ADDENDUM # 1

November 5, 2021

**Bataan Lift Station Renovation
Bid No. 2021-09**

Bohannon Huston Inc.

BHI PROJECT NO.	20210255	DWG NO.	E-600-R1	SHEET OF	27	29
-----------------	----------	---------	----------	----------	----	----

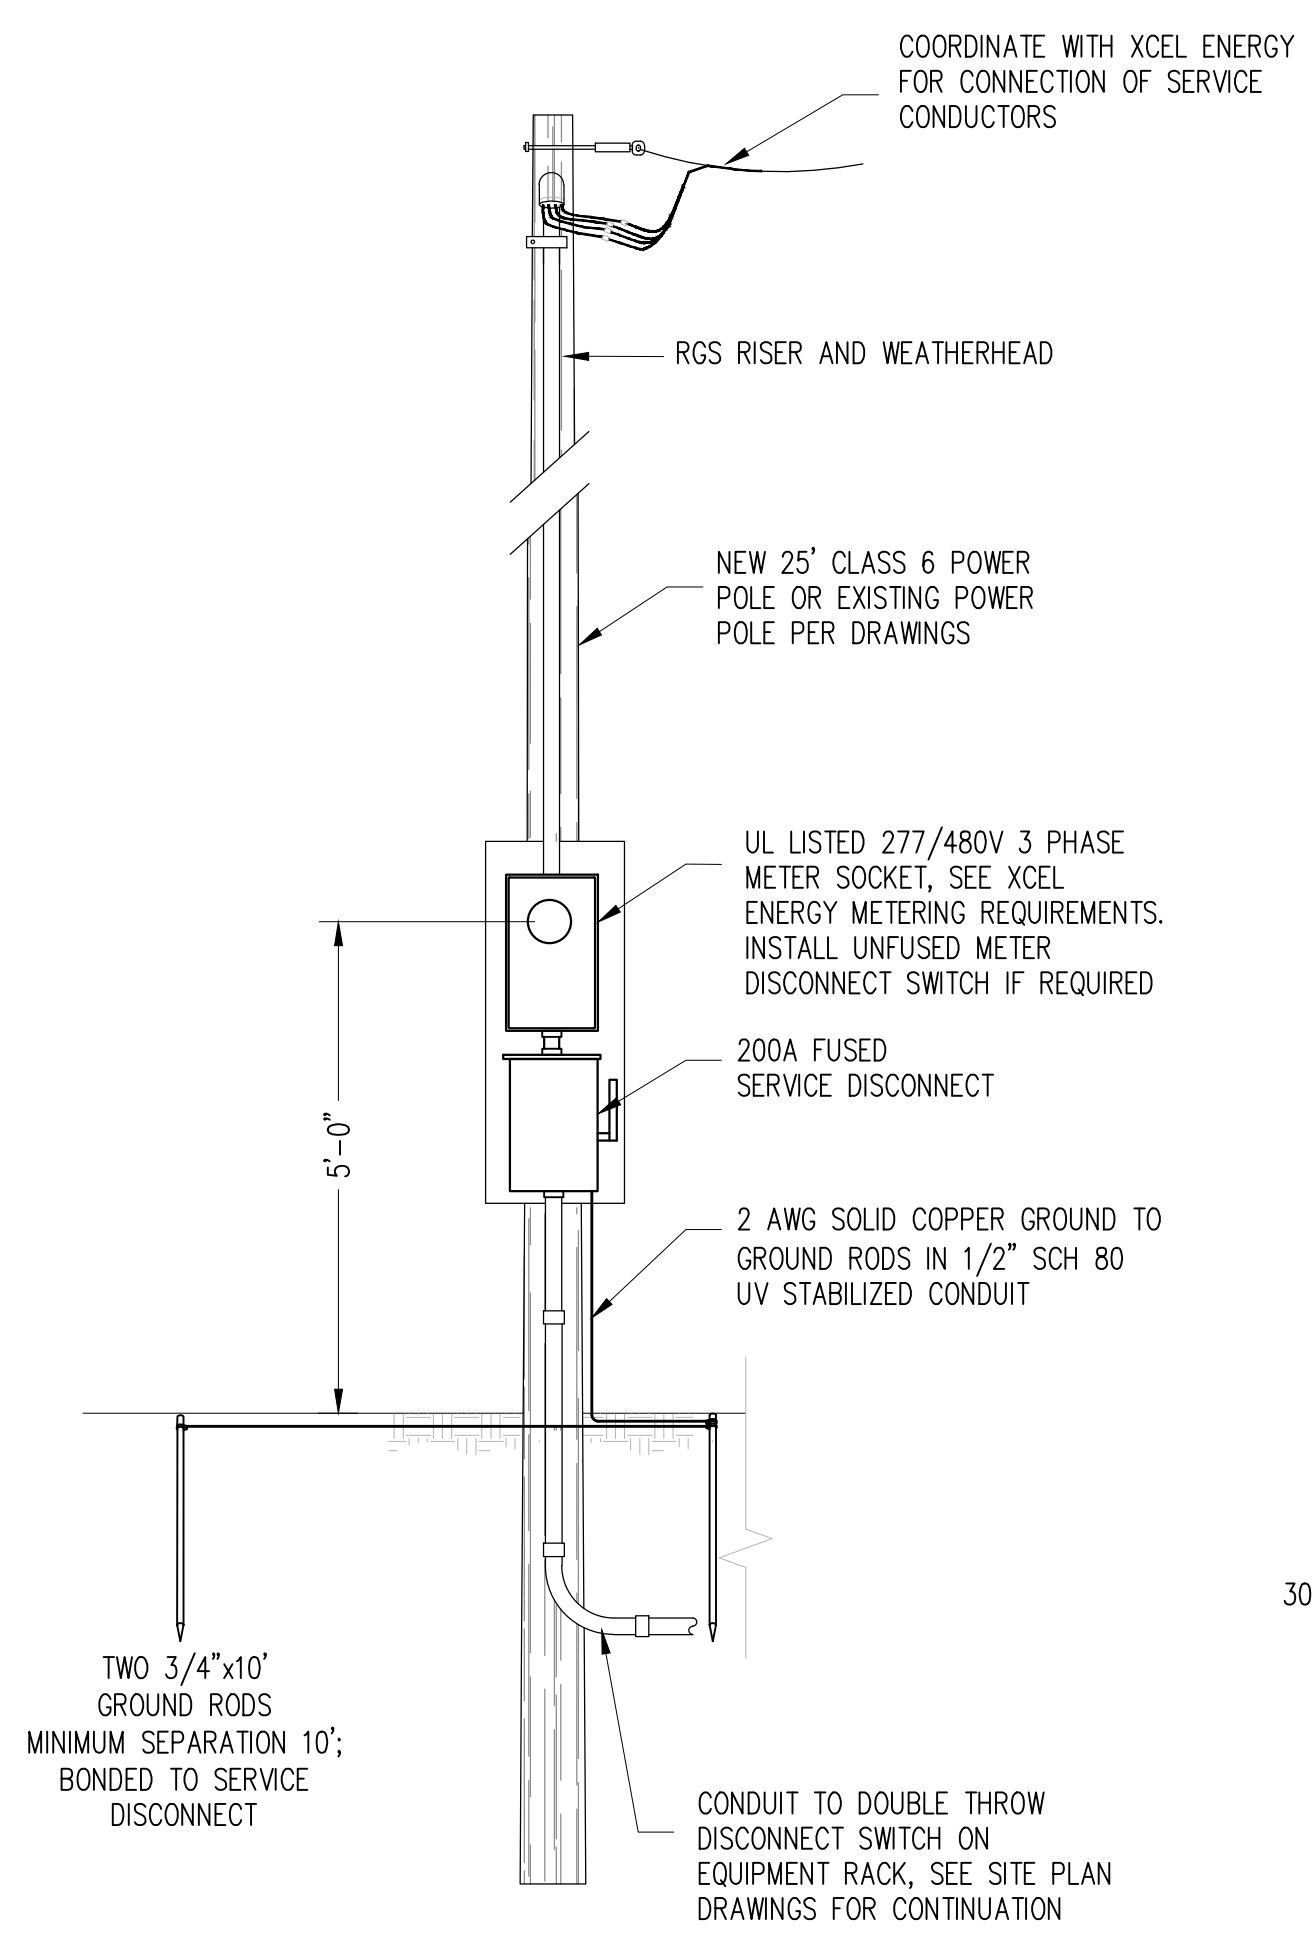
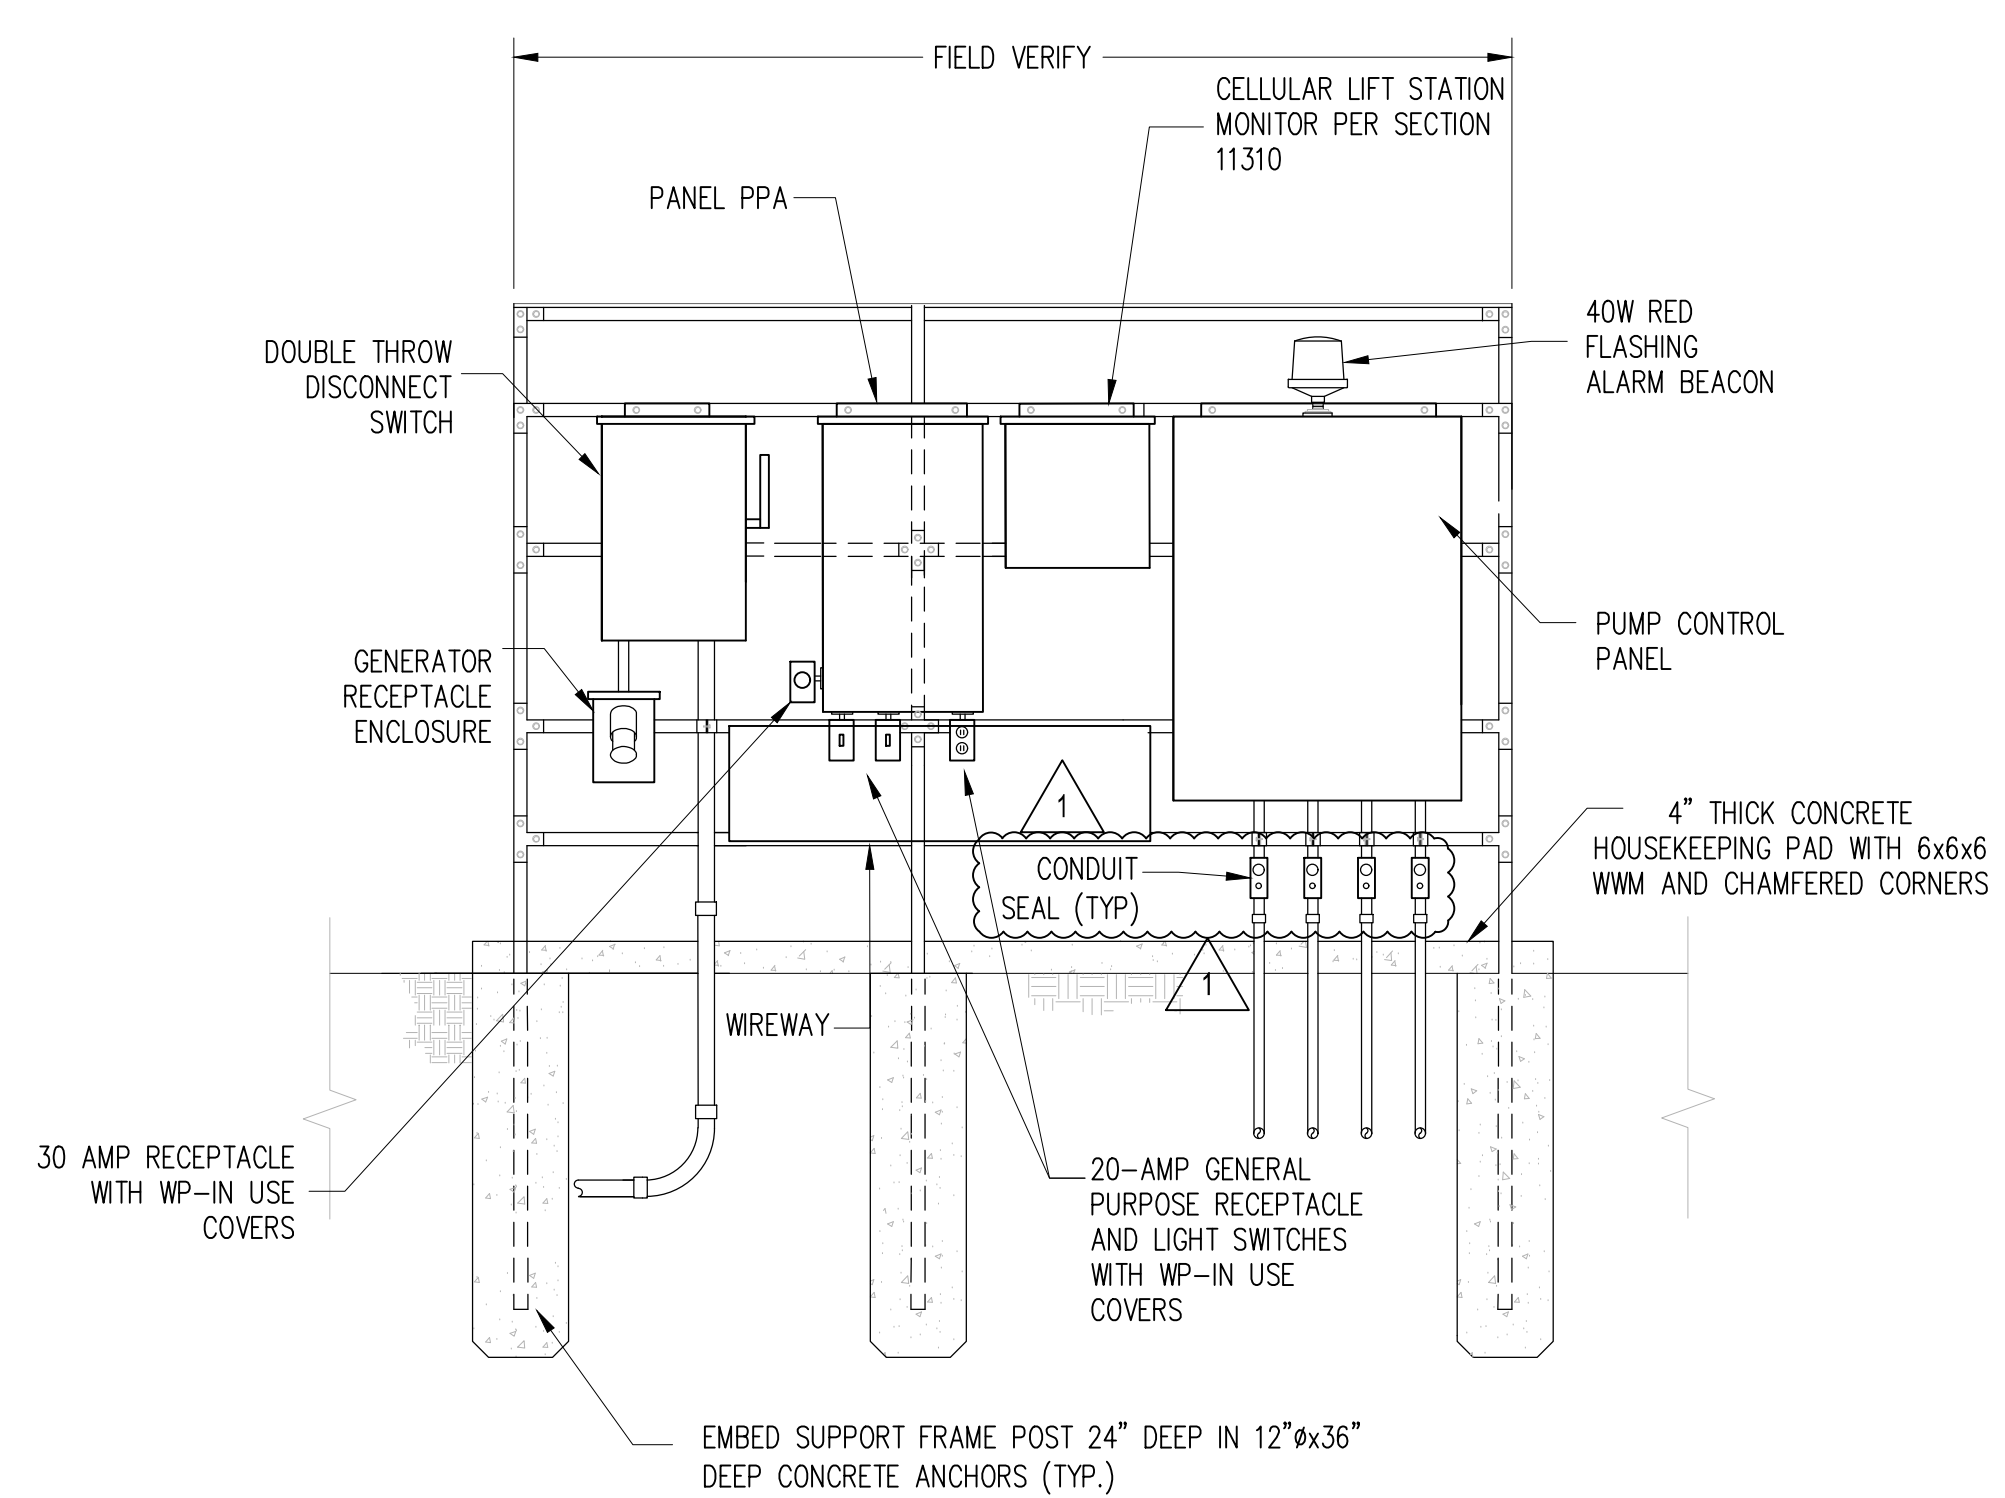
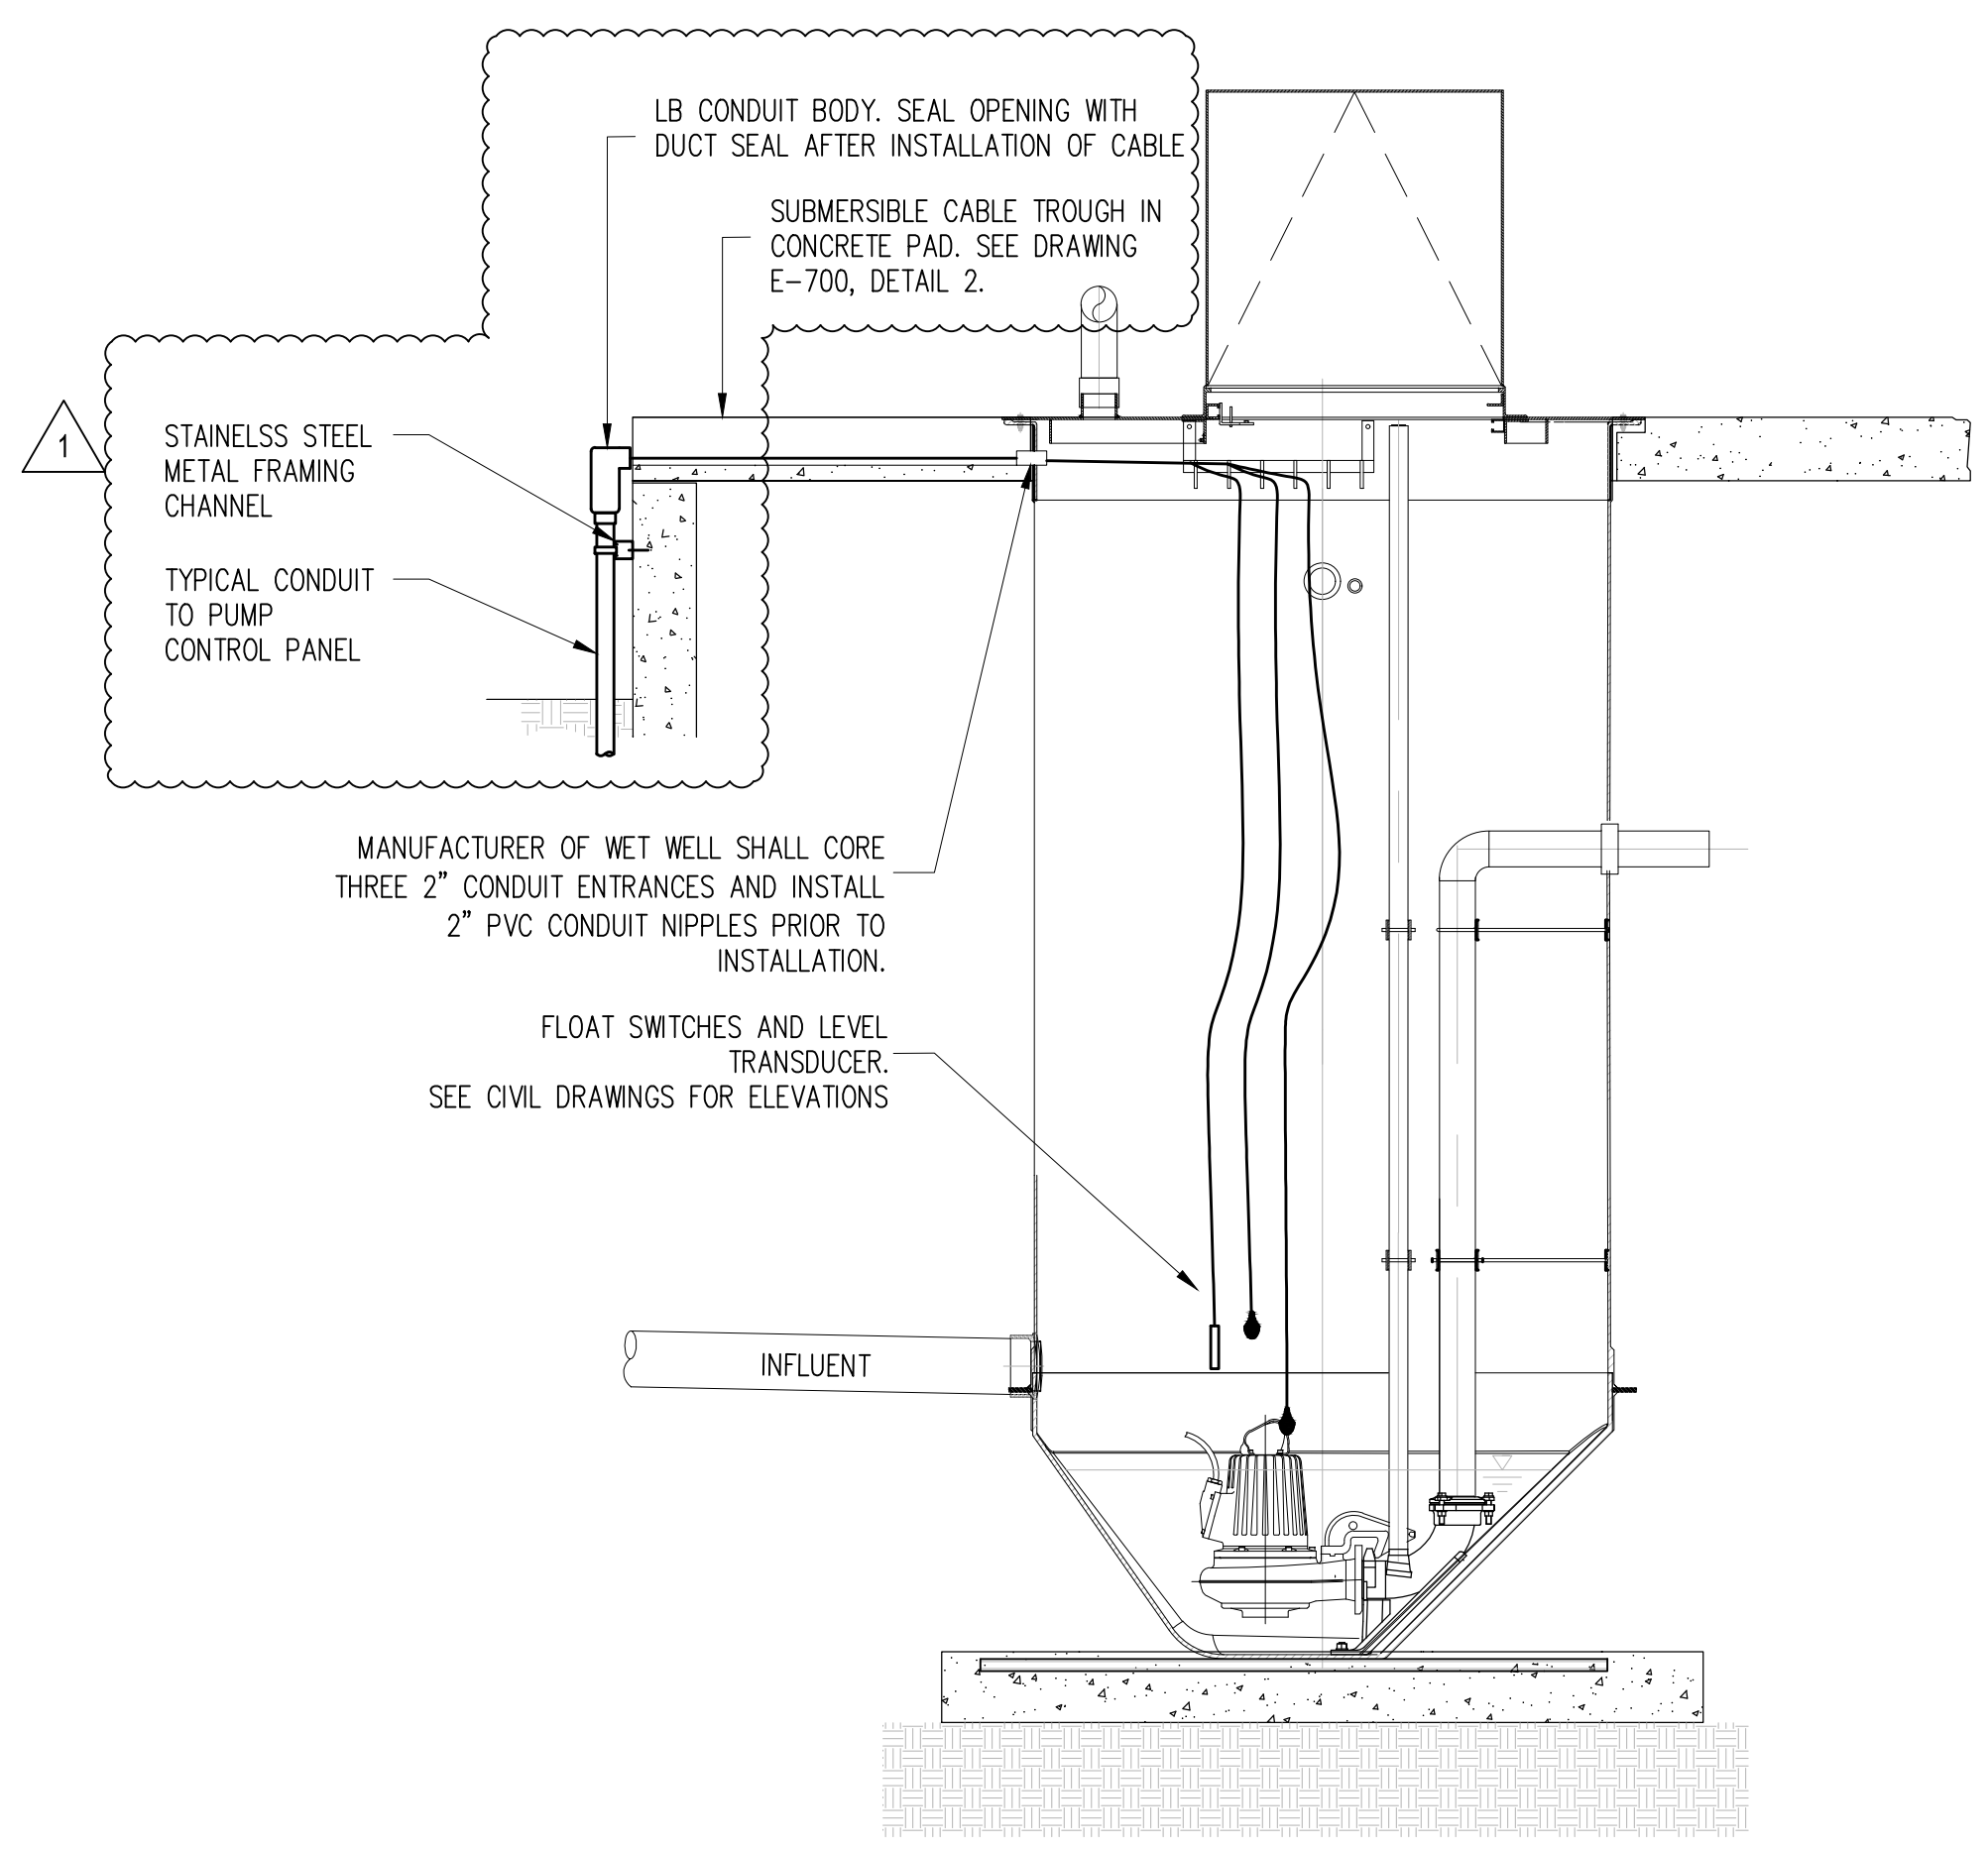
6. **Drawing E-500-R1**: Deleted submersible cable junction box from one line diagram.
7. **Drawing E-600-R1**: Revised lift station wet well detail to show conduit routing to control panel and deletion of submersible cable junction box; Revised equipment rack detail to show addition of conduit seals entering control panel.
